05-029r0 SAS-1.1 transmitter and receiver transients subsection January 6, 2005

To: T10 Technical Committee
From: Alvin Cox, Seagate (Alvin.cox@seagate.com)
Date: January 6, 2005
Subject: 05-029r0 SAS-1.1 transmitter and receiver transients subsection

Figure 63 — Transmitter transient test circuit

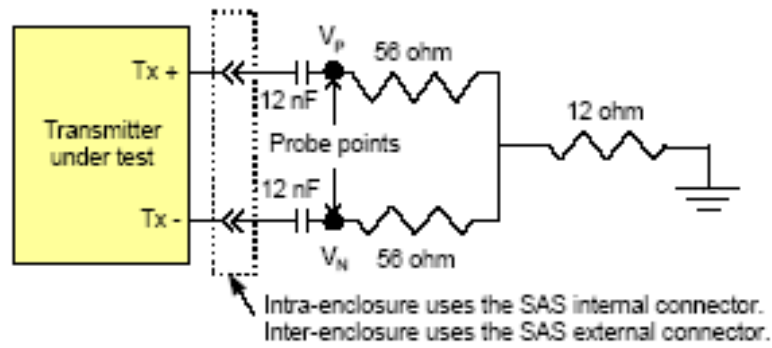
Move Figures 63 (Transmitter transient test circuit) and 64 (Receiver transient test circuit) to 5.3.x.

The maximum transmitter and receiver transients are measured at nodes VP and VN with respect to GROUND on the test loads shown in figure 63 (for the transmitter device) and figure 64 (for the receiver device) during all power state and mode transitions. Test conditions shall include the

system power supply ramping at the fastest possible rate for both power on and power off conditions, voltage sequencing, and mode transitions.
